**Docket A-98-49
Item V-B2-1**

**COMPLIANCE APPLICATION REVIEW DOCUMENTS
FOR THE CRITERIA FOR THE CERTIFICATION
AND RECERTIFICATION OF THE
WASTE ISOLATION PILOT PLANT'S
COMPLIANCE WITH THE
40 CFR PART 191 DISPOSAL REGULATIONS:
FINAL RECERTIFICATION DECISION**

**U.S. Environmental Protection Agency
Office of Radiation and Indoor Air
Washington, D.C. 20460**

March 2006

Figure 15-2. The WIPP Site is to the East of Nash Draw and Topographically Higher Than Nash Draw. Response to Precipitation Events at Surprise Springs Reflect Flow in Nash Draw, but not at the WIPP Site, Which is Over 8 Miles From the Land Withdrawal Boundary.

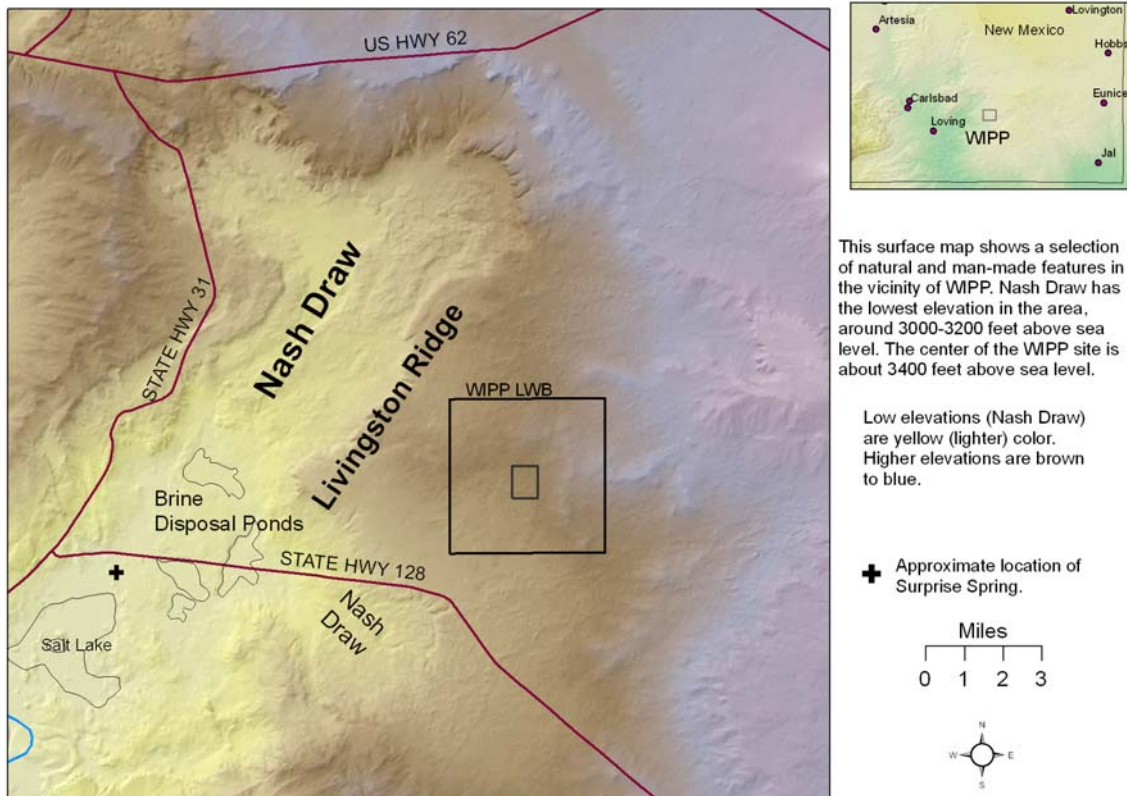
Because EPA's release requirements apply to the site, our primary interest is what happens at the WIPP site, that is, within the land withdrawal boundary (LWB), because the LWB defines the accessible environment. However, to get a better understanding of the WIPP site, it is useful to look at the area around the WIPP site. The land surface at the WIPP site generally slopes to the south and southwest. There is a topographic high, Livingston Ridge, northwest of the site, which is adjacent to Nash Draw, a topographic depression, further west (Figure 15-2).

Figure 15-4. Four Hydrochemical Facies in the Culebra Siegel et al. 1991

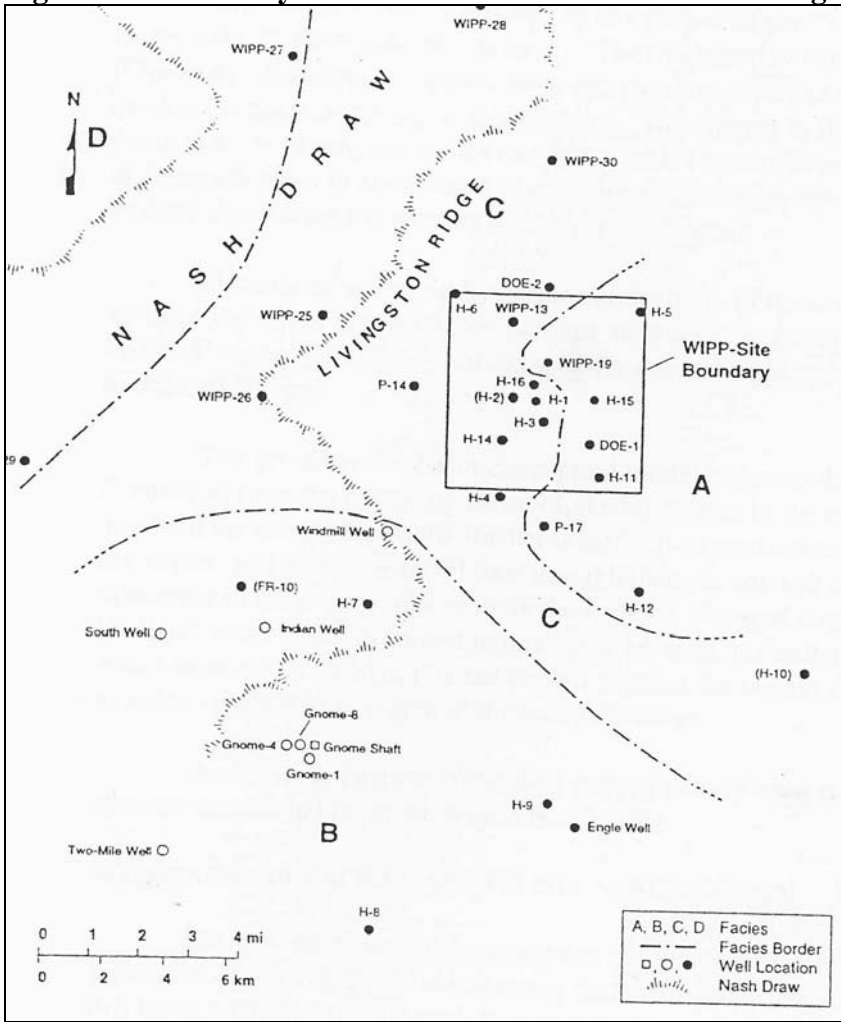
EPA believes that, on a regional scale, the groundwater basin model done by DOE reasonably predicts the current ground water flow regime and the geochemistry of the site.

Figure 34.1. Mean and Quantile CCDFs for Total Normalized Releases: All Replicates of the CRA-2004 PABC (from Figure 6-4, 2004 Compliance Recertification Application Performance Assessment Baseline Calculation, Docket A-98-49, Item B2-51)

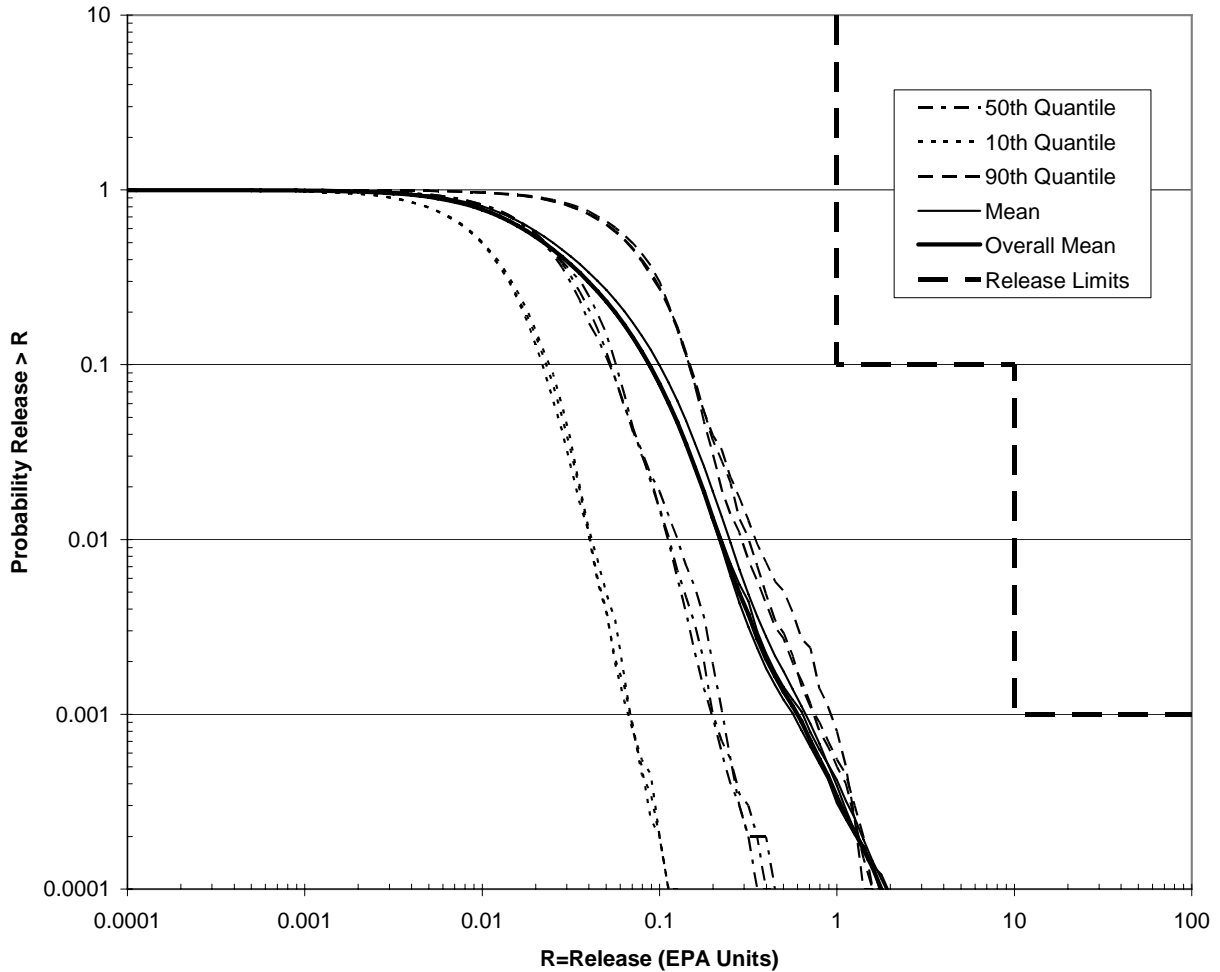
DOE used selected computer codes and input parameters to generate estimates of radionuclides for a large number of release scenarios. In total, 300 CCDFs (100 for each of the three replicates) were constructed and presented in the Performance Assessment Baseline Calculation Report (Docket A-98-49, Item II-B2-60) for total normalized releases (Figure 34-1). Three hundred realizations were needed in order to satisfy the requirements of Section 194.34(d). Normalized release results for ten thousand future simulations were used to calculate each of the 300 CCDF curves. In addition, DOE provided CCDFs for individual pathways and by replicate. EPA's analysis (Docket A-98-49, Item II-B1-16) concluded that DOE adequately presented the PA results in CCDFs, which show the probability of exceeding various levels of cumulative releases.

Figure 34-2. Total Normalized Releases for 100 CCDFs of Replicate R1 of the CRA-2004 PABC (Figure 6-1, PABC Report, Docket A-98-49, Item II-B2-60).

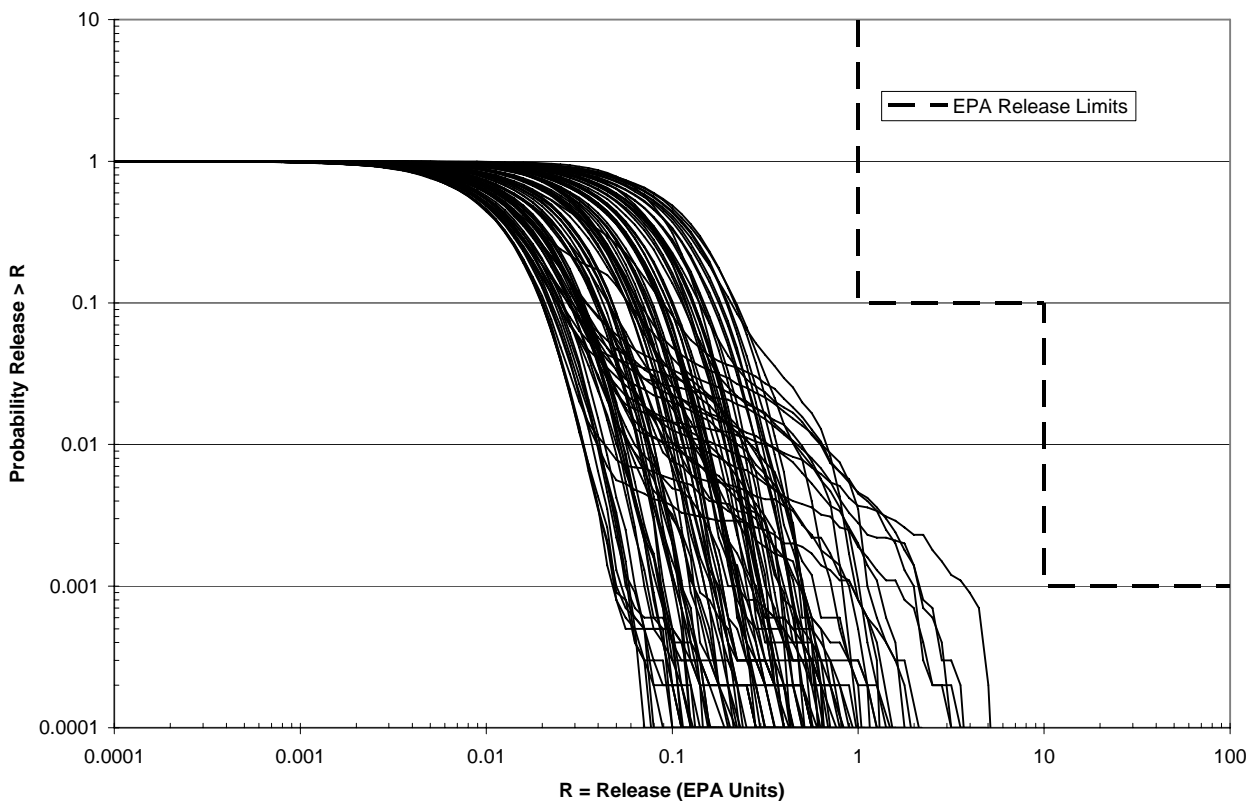
DOE presented and discussed the results of the performance assessment analysis in the 2004 CRA, Chapter 6 and the PABC report, Chapter 6 (Docket A-98-49, Item II-B2-60). Figure 34-2 shows the releases from replicate R1 of the CRA-2004 PABC.

Based on a review and evaluation of the 2004 CRA and supplemental information provided by DOE (FDMS Docket ID No. EPA-HQ-OAR-2004-0025, Air Docket A-98-49) and the fact that DOE included the full range of CCDFs as required by this section, EPA determines that DOE continues to comply with the requirements for Section 194.34(e).
